**DUKE POWER COMPANY
NUCLEAR GENERATION DEPARTMENT**

**ODCM
OFFSITE DOSE CALCULATION
MANUAL**

Subject: Offsite Dose Calculation Manual (ODCM)
Generic Section - Revision 43

GASEOUS WASTE SYSTEM
 OCONEE NUCLEAR STATION
 FIGURE A1.0-2
 PAGE 1 OF 4

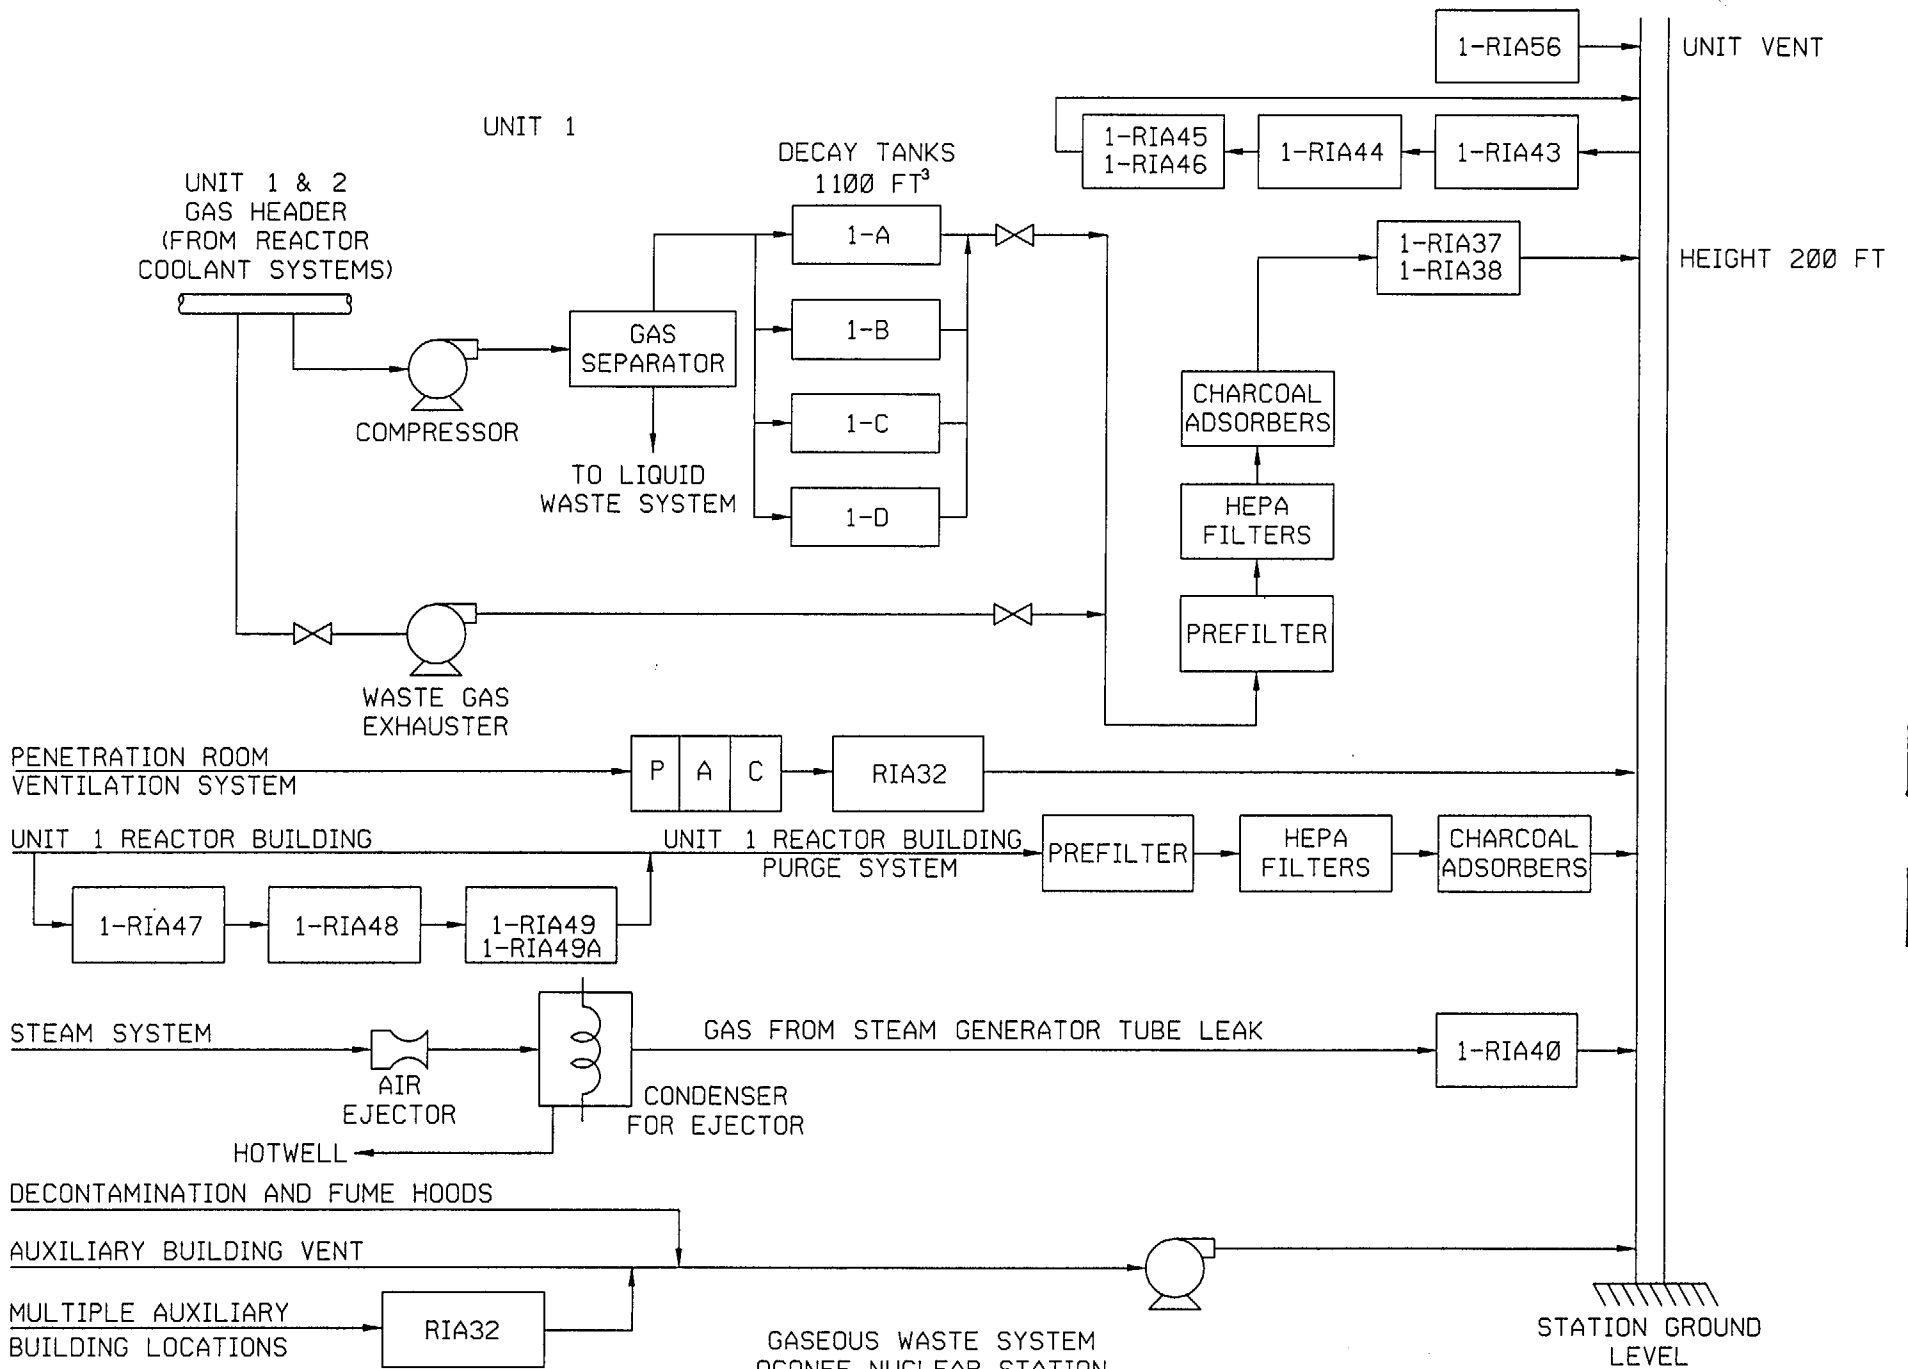
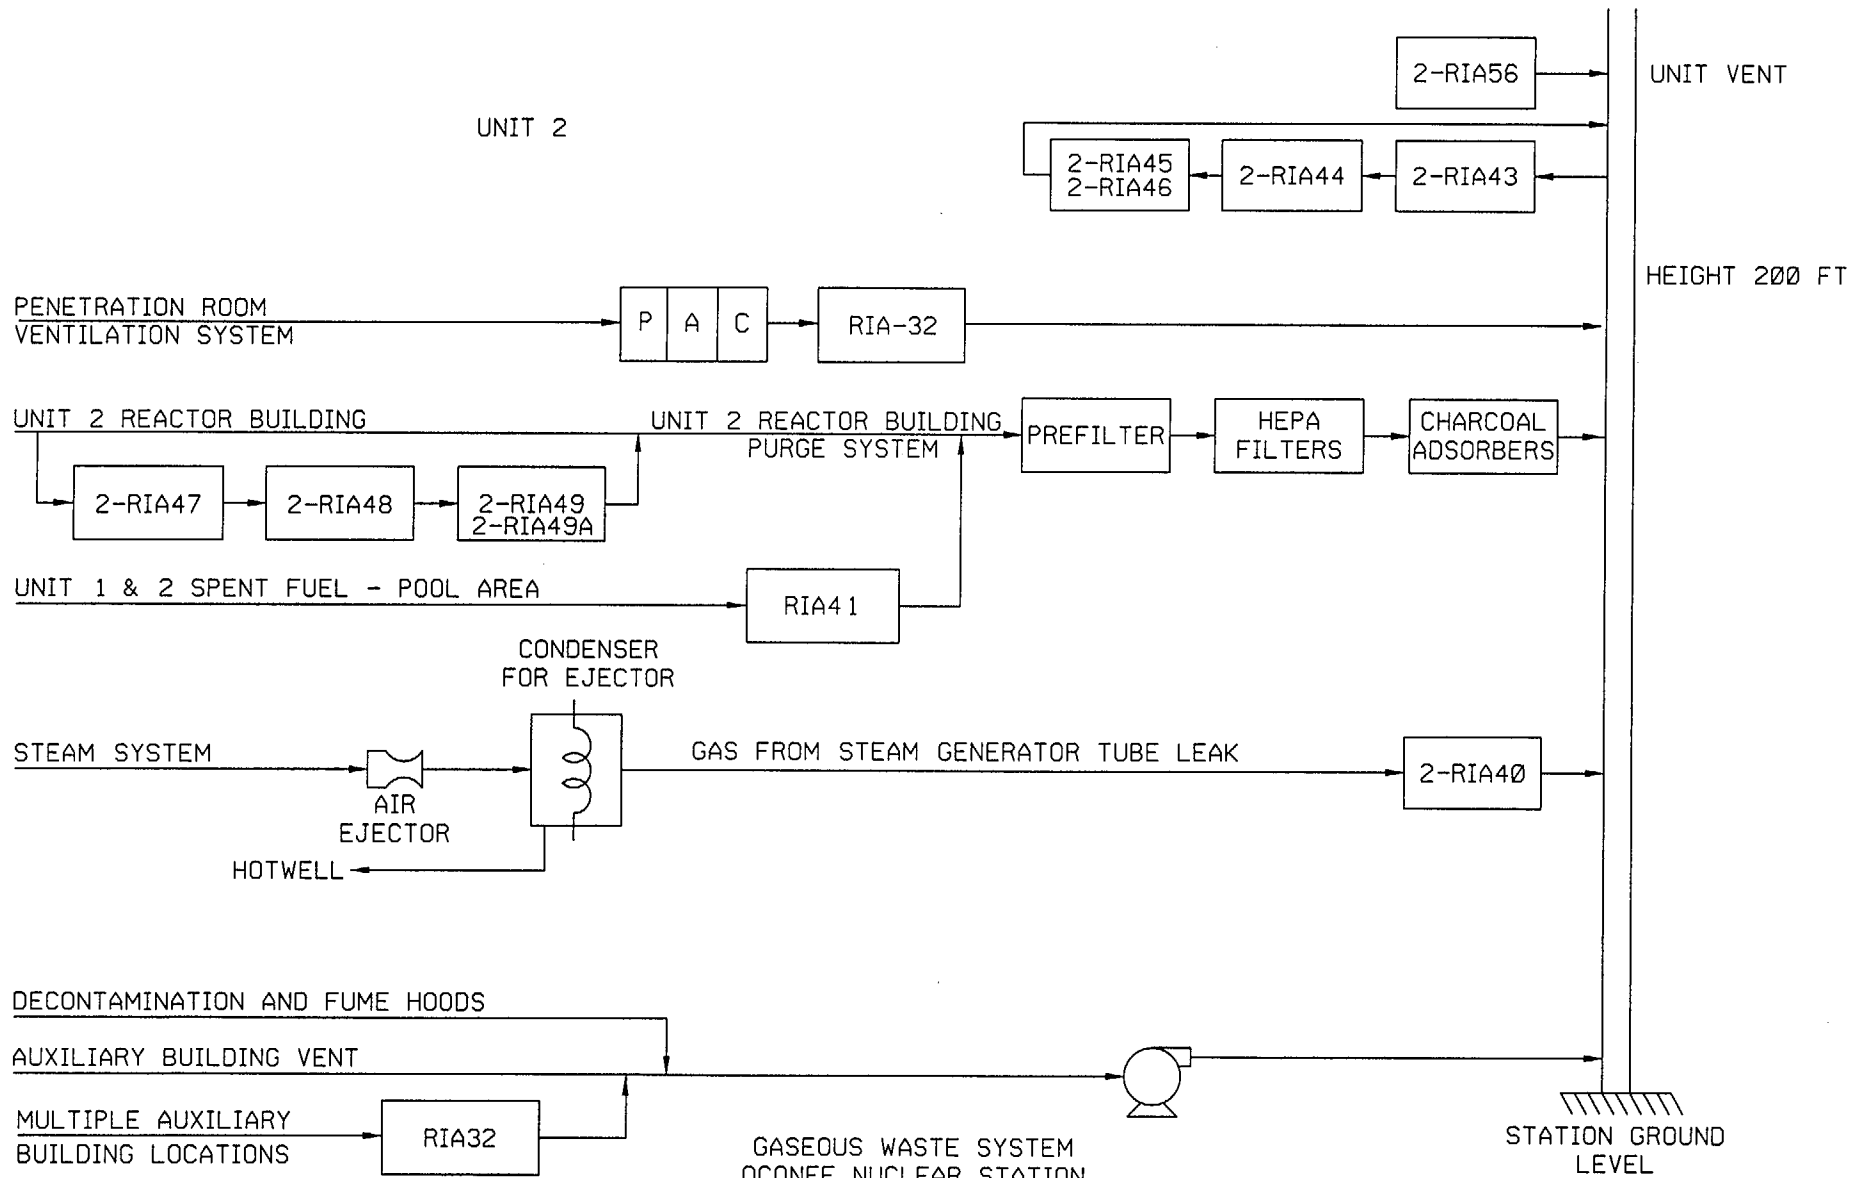
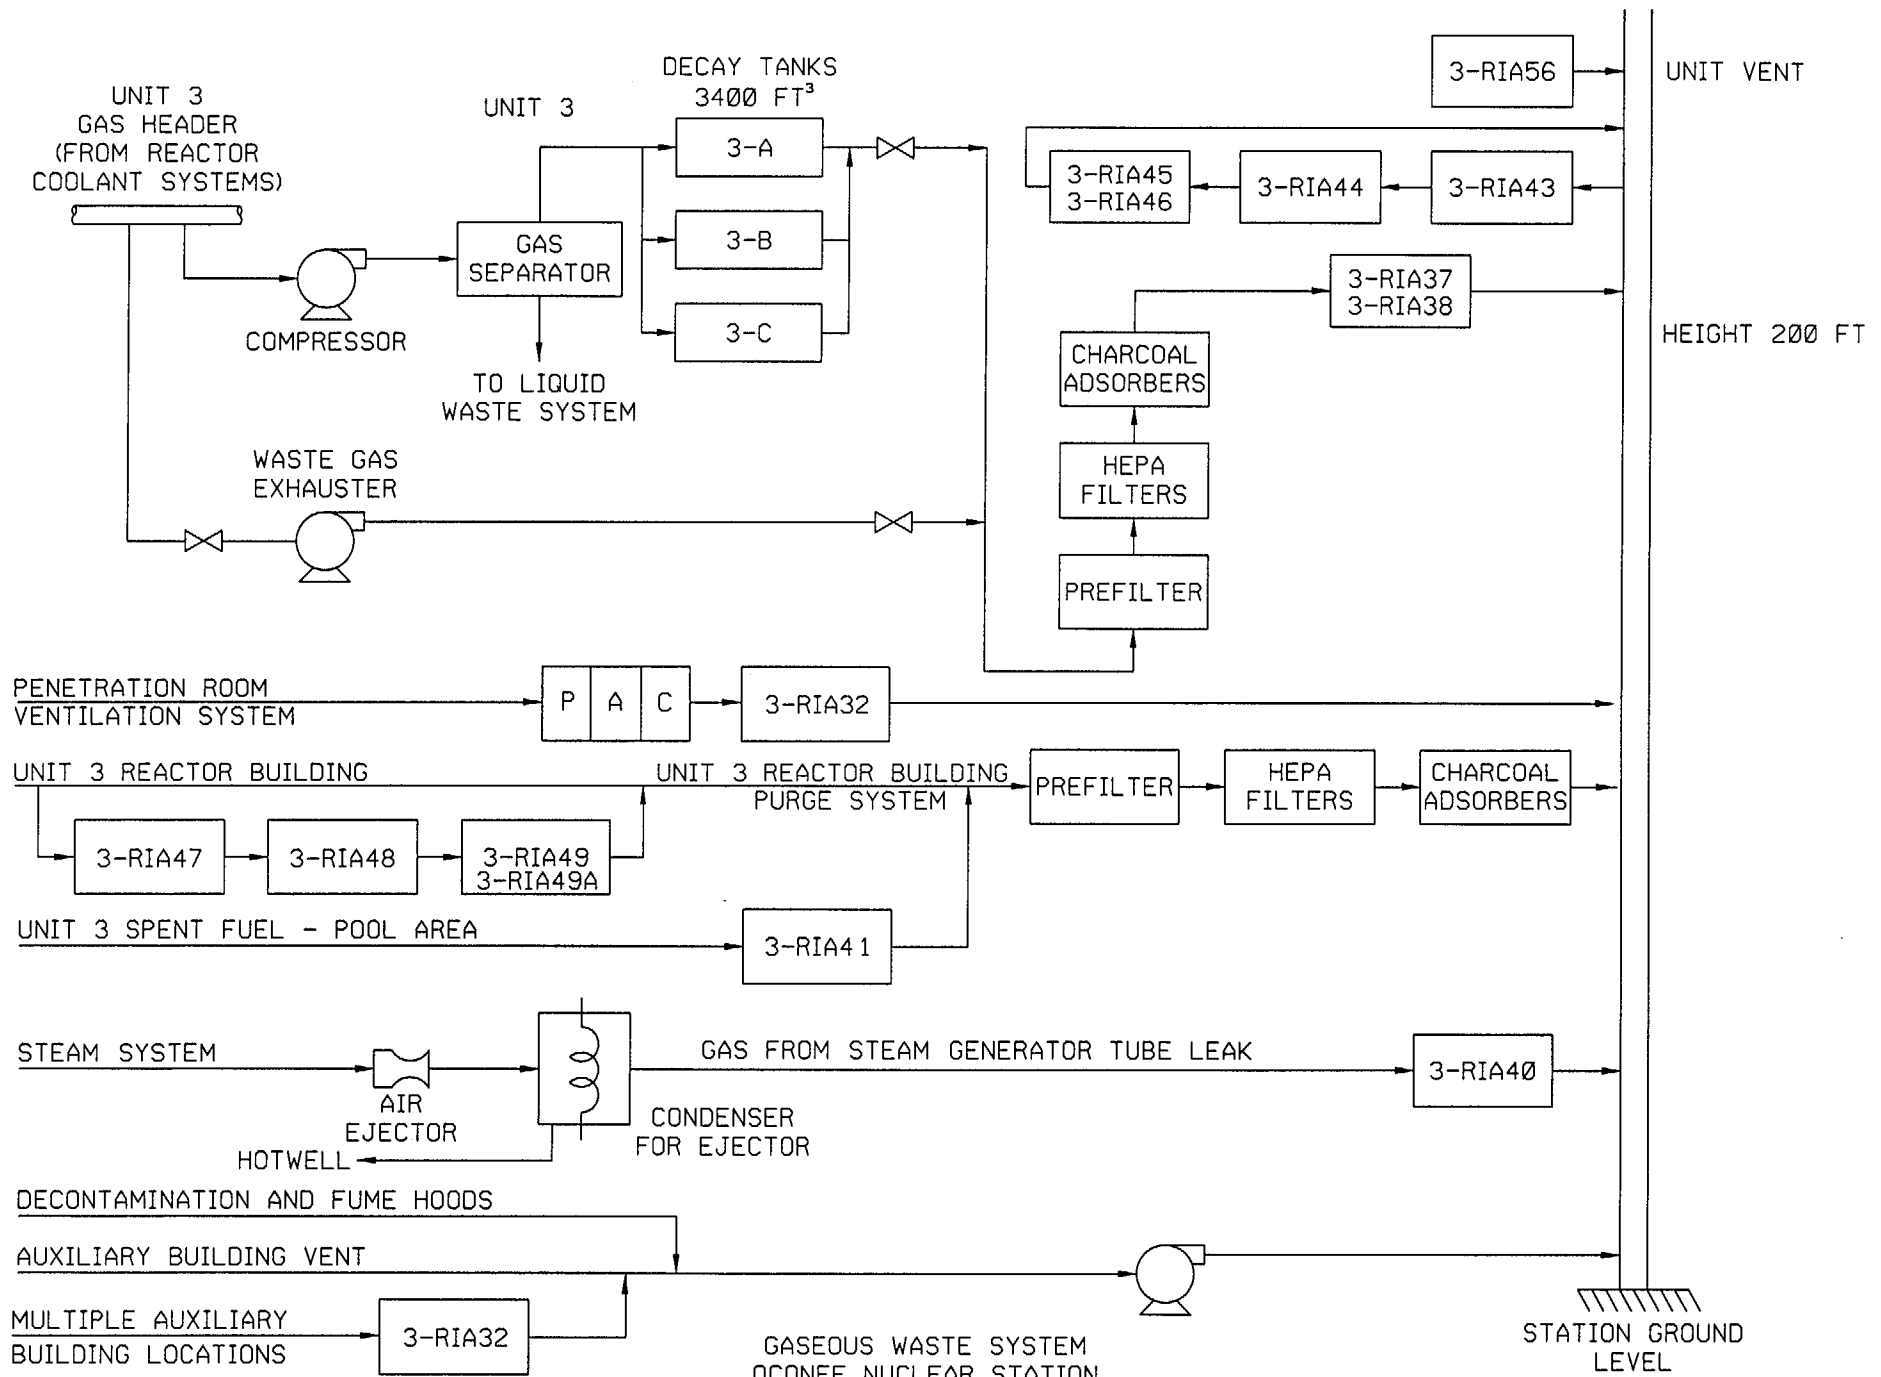
Monitor designations updated to reflect current design. Monitor changes were due to recent modifications to the plant radiation monitoring system. RIA-49A on each of the 3 Units was added during the modification. Units 1&2 RIA-32 replaced 1 RIA-51 and 2 RIA-51, and Unit 3 RIA-32 replaced 3 RIA-51. RIA-56 on all 3 Units monitors the Unit Vent directly, rather than through an off-line process as had been indicated in the previous figures. The Interim Radwaste Facility ventilation system exhaust is monitored by a flow rate measuring device, rather than a flow totalizer as had been indicated in the previous figure.
